3.0 + Dwelling Information

Block A - GA Plans - Drawing No. 0203

Approved NMA Drawing (Ref:220434)

NMA Site wide Amendments - to be approved
01	Levels amended to east-west route through the landscape area, resulting in changes to the levels of the play mounds adjacent and omission of the retaining walls proposed previously adjacent to the path.
02	Additional refuse collection bay included adjacent to the new apartment refuse store and landscaping amended accordingly.
03	Riversley Court proposed refuse bay extended by 3.7m into the central green space.
04	Tree to the south of 203 Irving Court on the Wensley Road junction, relocated to a larger tree pit in the north-west corner of the new 203 parking court. Tree to east of 203 Irving Court relocated to a larger tree pit in the north-east corner of the new 203 parking court.
05	To provide sufficient space for the Wensley Hub, 5 proposed trees to be relocated offsite - located within the Coley Ward.
06	Relocation of 9 proposed trees adjacent to C1 and C2 and planting changed from herbaceous to grass in this area.

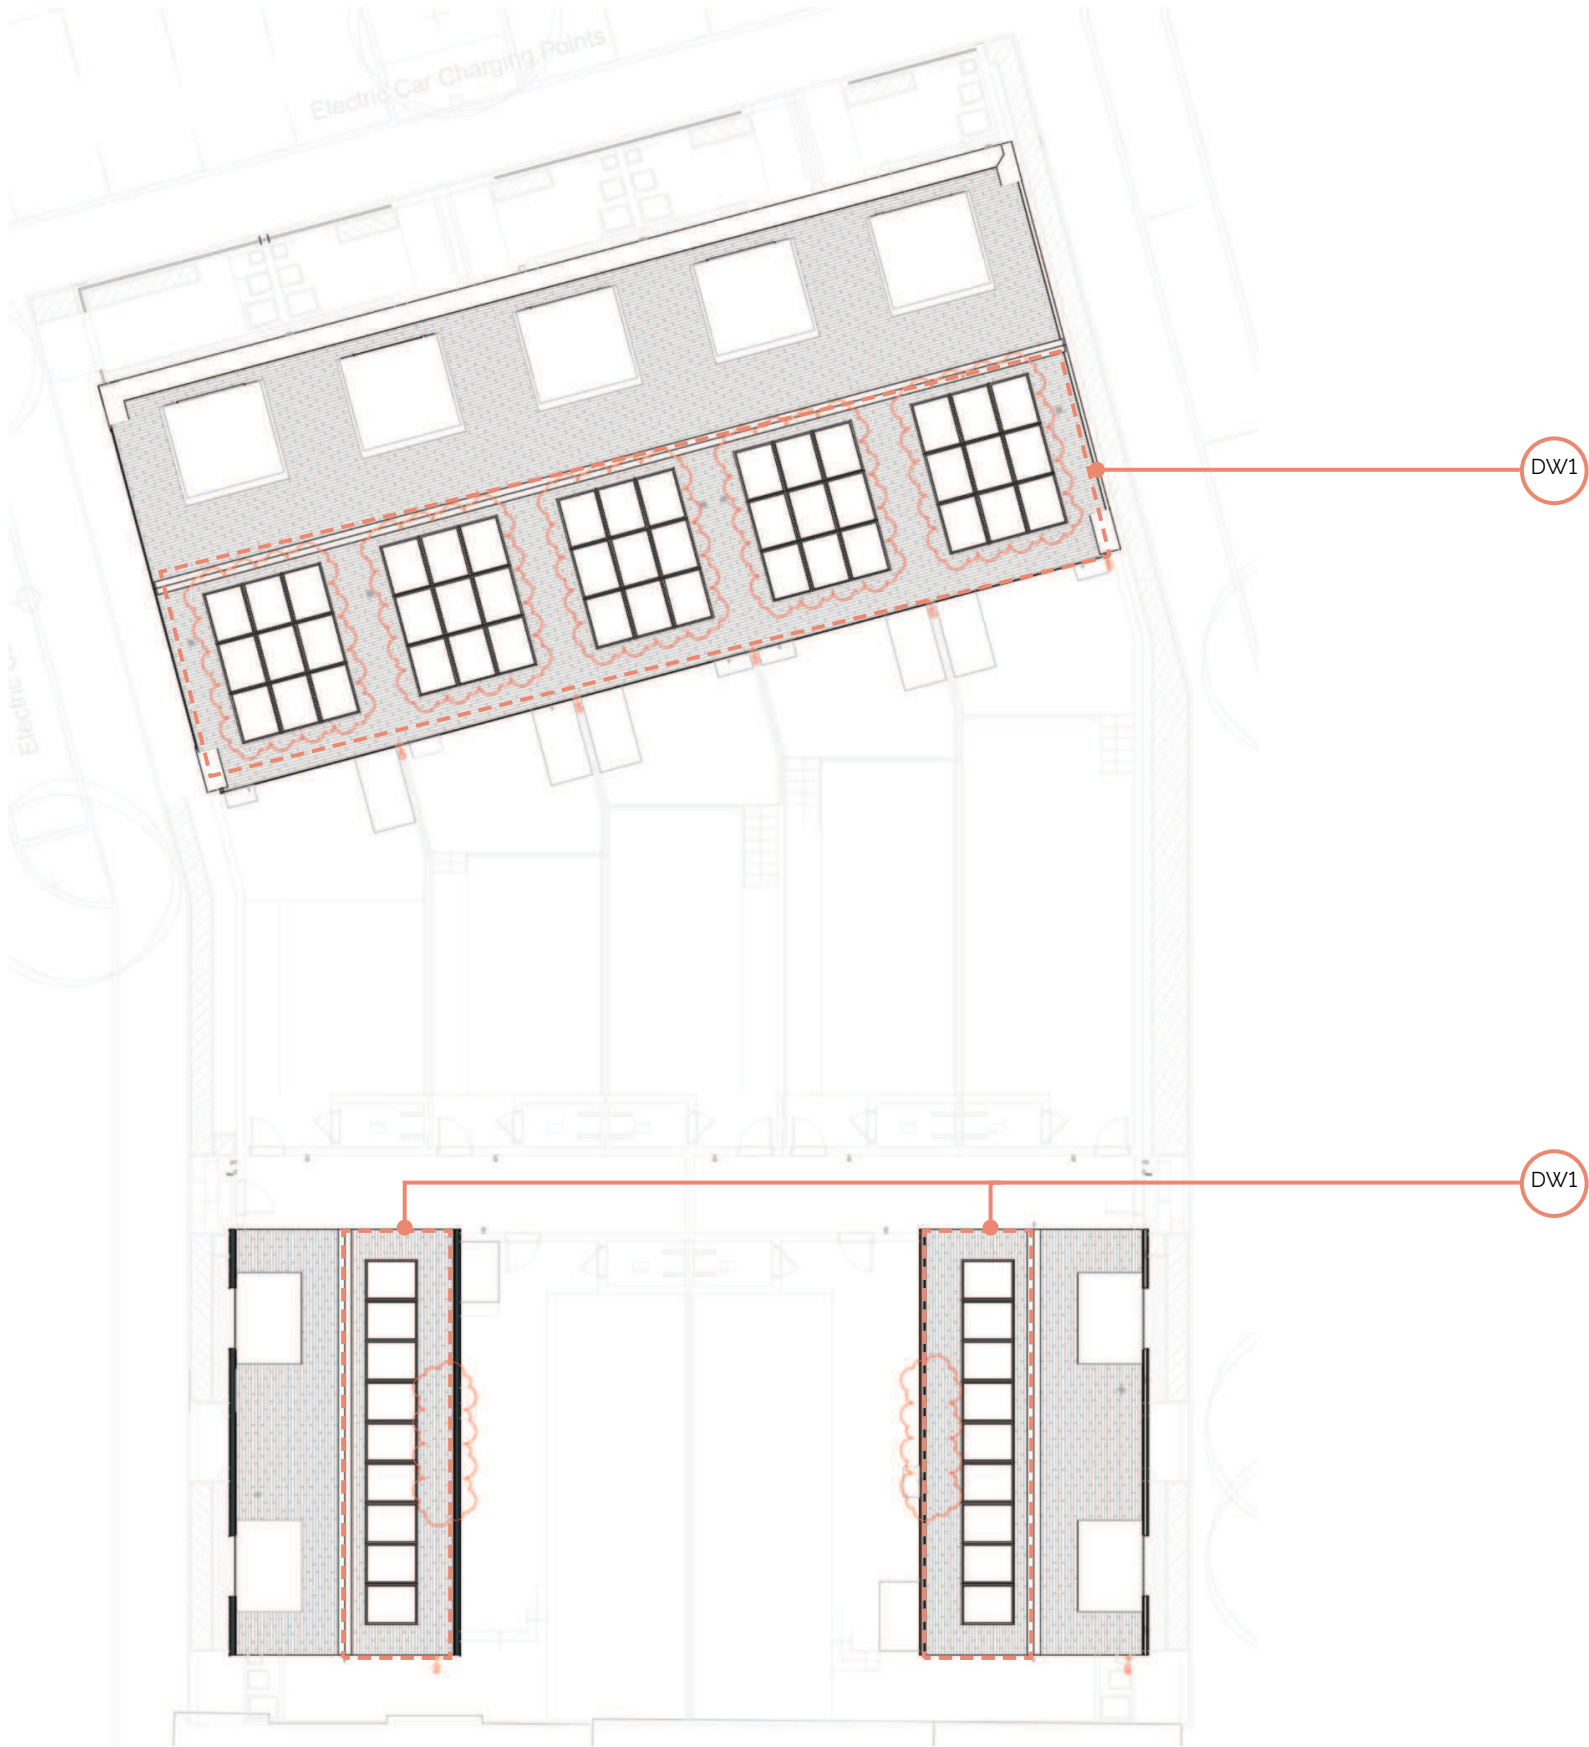
D	Areas of impermeable paving changed to permeable.
E	Tree species types amended
F	Material to perimeter of central green space changed to match general pavements.
	Dwelling Amendments - to be approved
DW1	Overall number of PV panels to remain the same. Number of PV panels on each of the seven houses in the C2 terrace increased by 3 provided by omitting 1 panel from the other 21 houses.
DW2	Block B2 Stair rooflight increased from 1910mm to 2500mm
DW3	Reposition of stair windows to rear of Block B2, with removal of central window recess

10.2 Block A - GA Plans

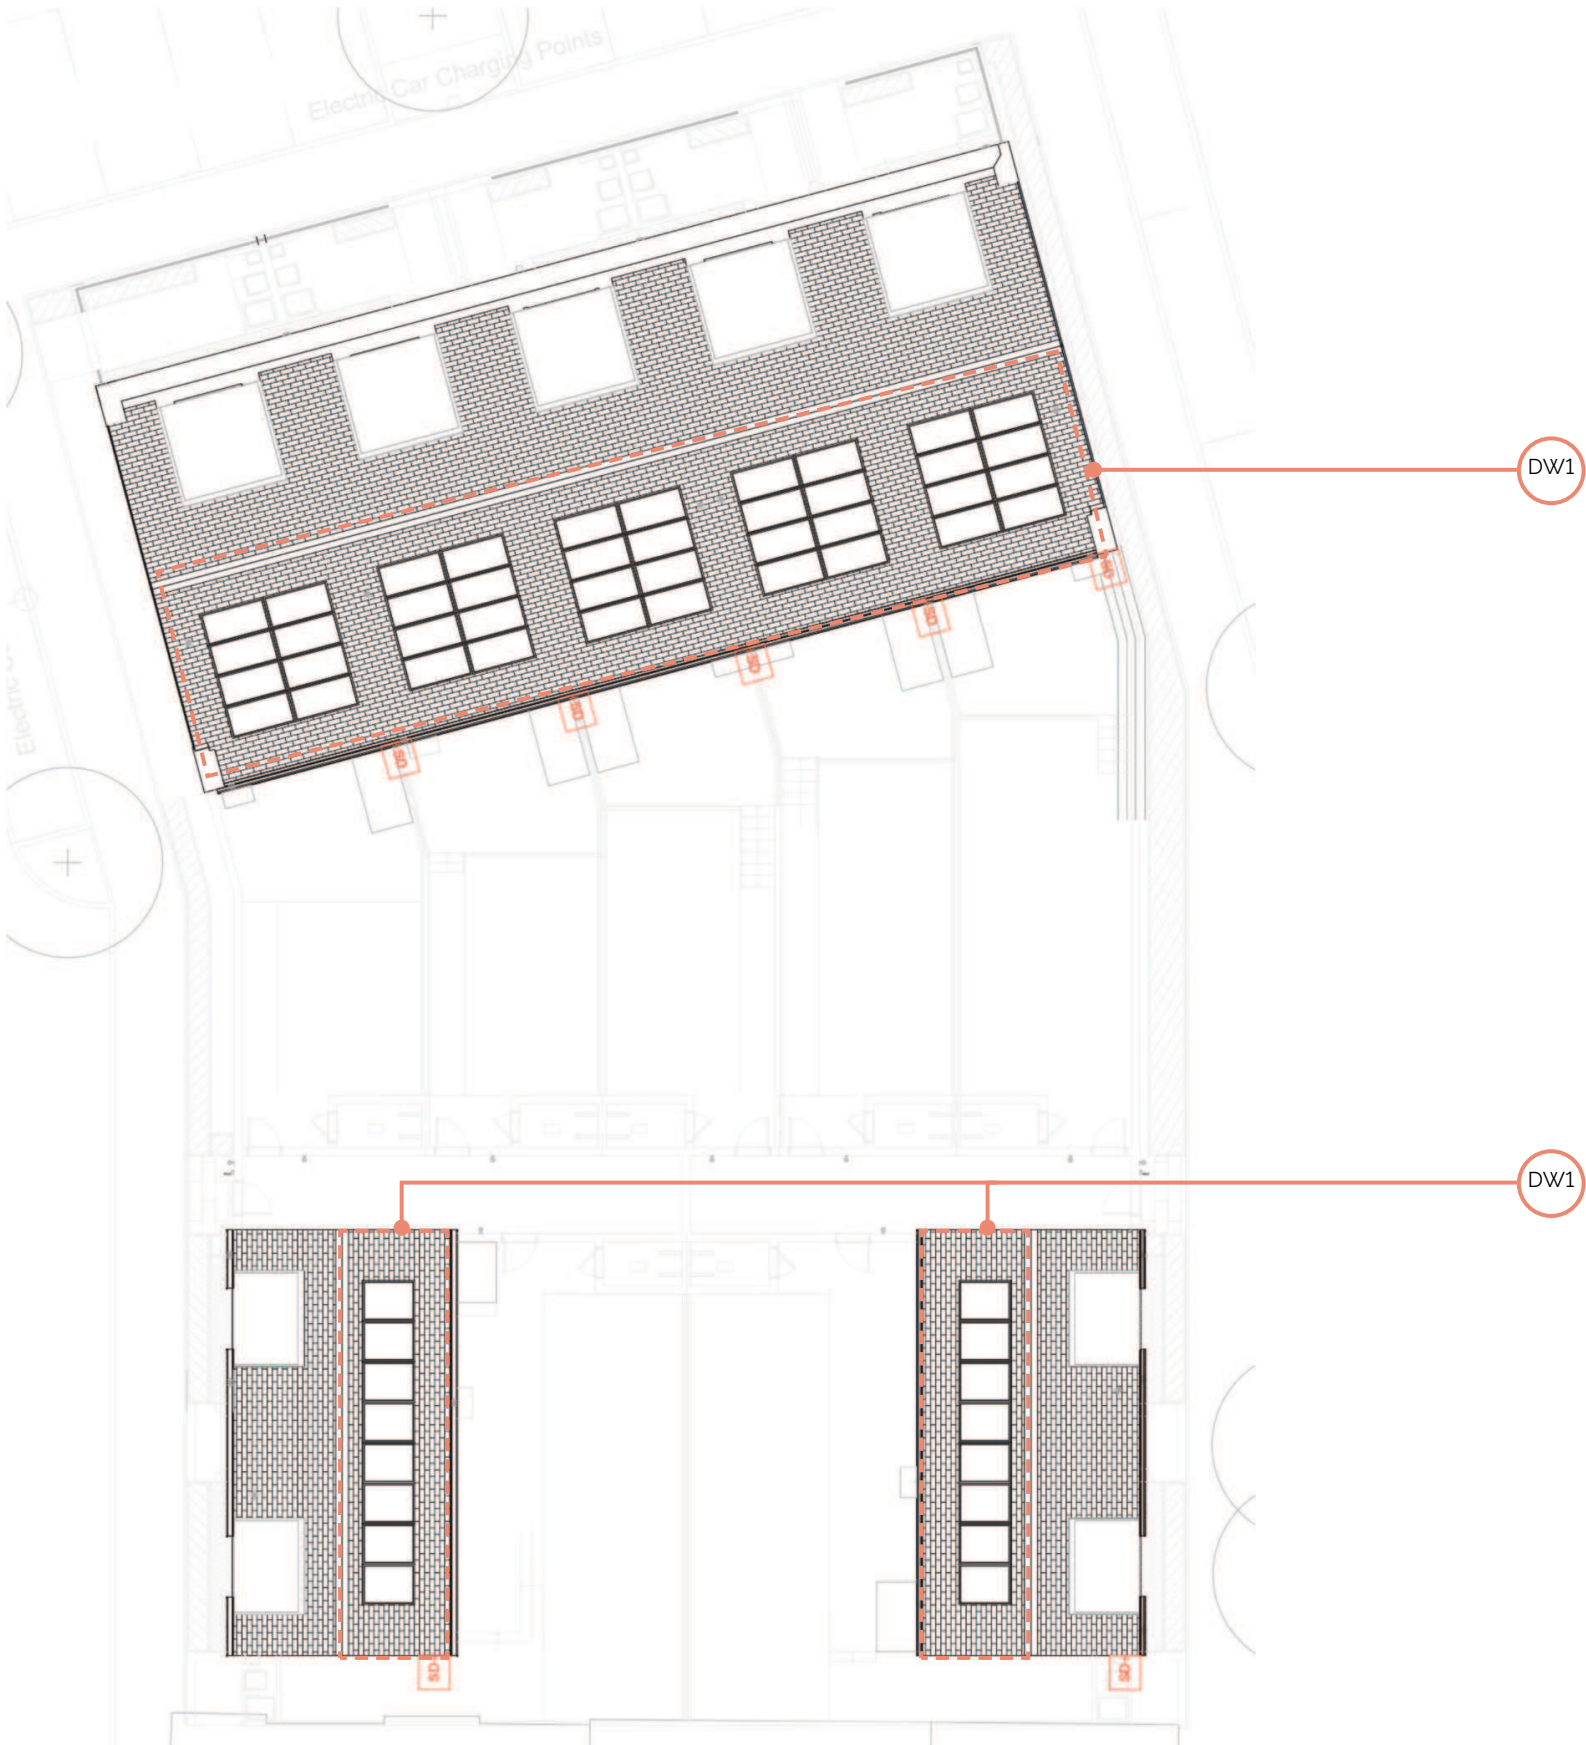
D	Areas of impermeable paving changed to permeable.
E	Tree species types amended
F	Material to perimeter of central green space changed to match general pavements.
	Dwelling Amendments - to be approved
DW1	Overall number of PV panels to remain the same. Number of PV panels on each of the seven houses in the C2 terrace increased by 3 provided by omitting 1 panel from the other 21 houses.
DW2	Block B2 Stair rooflight increased from 1910mm to 2500mm
DW3	Reposition of stair windows to rear of Block B2, with removal of central window recess

Block A2 Rear Elevation - Approved NMA Drawing (Ref:220434)

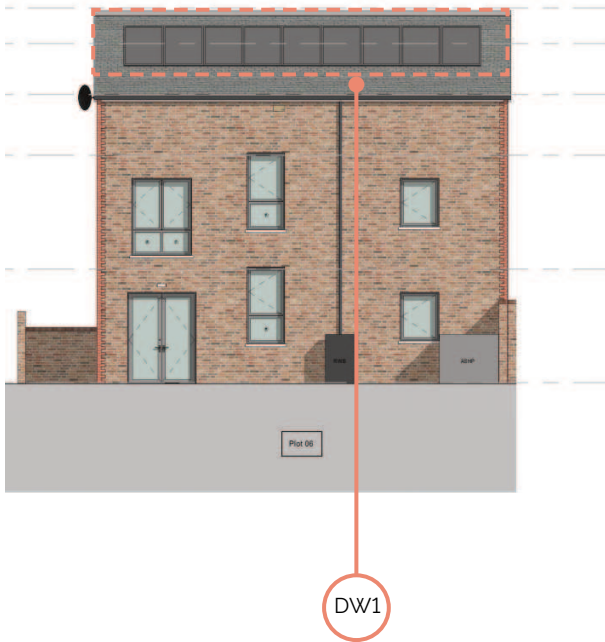
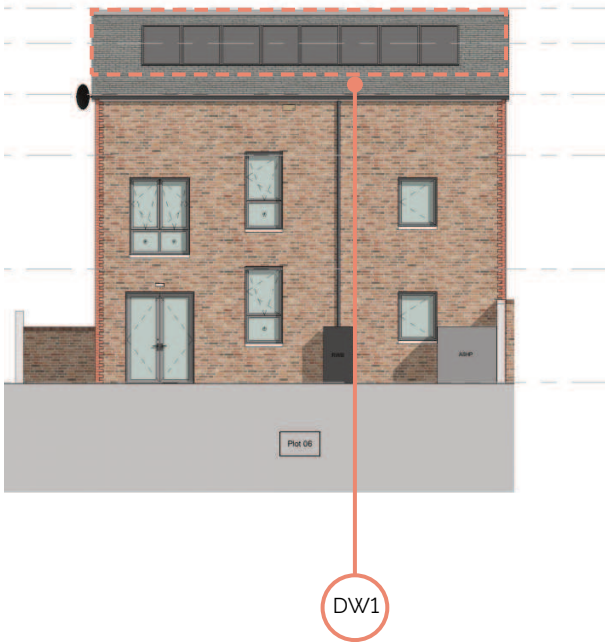
D	Areas of impermeable paving changed to permeable.
E	Tree species types amended
F	Material to perimeter of central green space changed to match general pavements.
	Dwelling Amendments - to be approved
DW1	Overall number of PV panels to remain the same. Number of PV panels on each of the seven houses in the C2 terrace increased by 3 provided by omitting 1 panel from the other 21 houses.
DW2	Block B2 Stair rooflight increased from 1910mm to 2500mm
DW3	Reposition of stair windows to rear of Block B2, with removal of central window recess

Block B2 North Elevation - Approved NMA Drawing (Ref:220434)

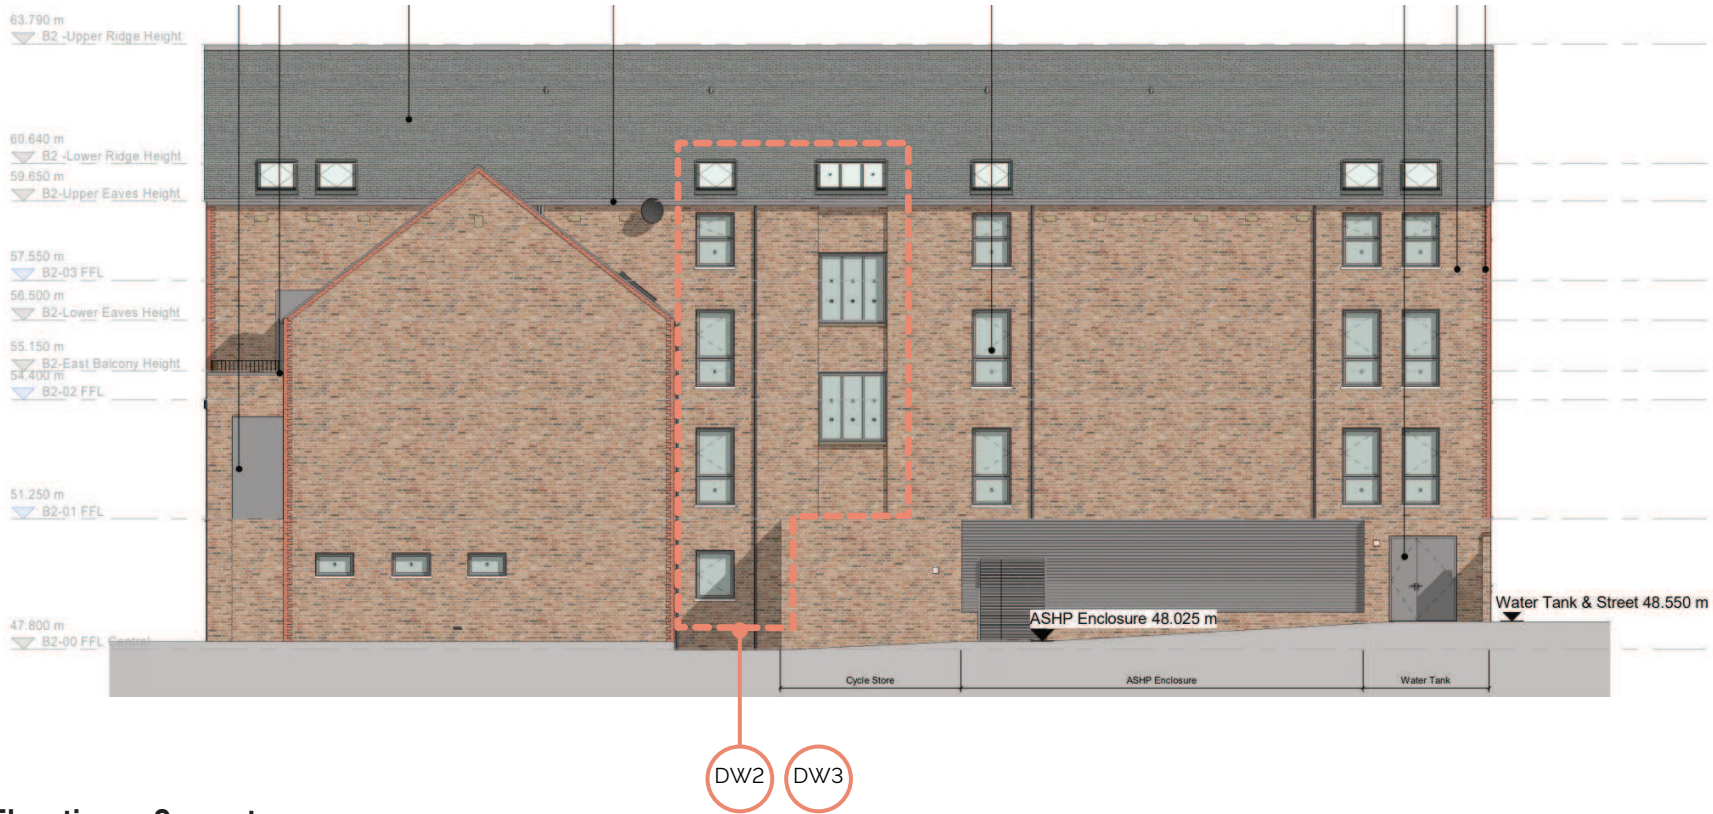
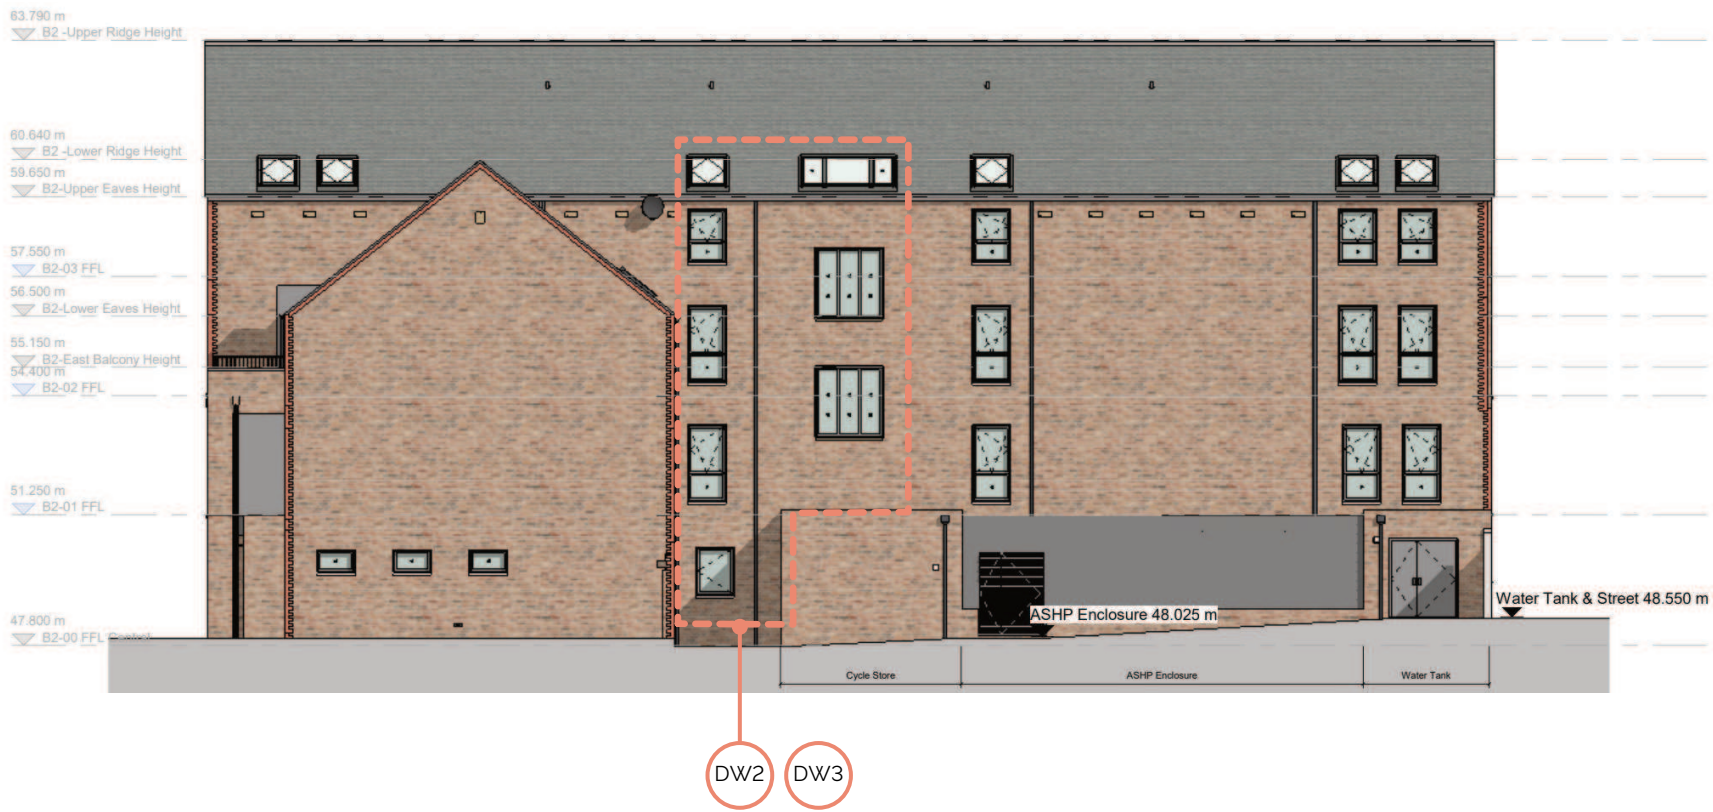
D	Areas of impermeable paving changed to permeable.
E	Tree species types amended
F	Material to perimeter of central green space changed to match general pavements.
	Dwelling Amendments - to be approved
DW1	Overall number of PV panels to remain the same. Number of PV panels on each of the seven houses in the C2 terrace increased by 3 provided by omitting 1 panel from the other 21 houses.
DW2	Block B2 Stair rooflight increased from 1910mm to 2500mm
DW3	Reposition of stair windows to rear of Block B2, with removal of central window recess
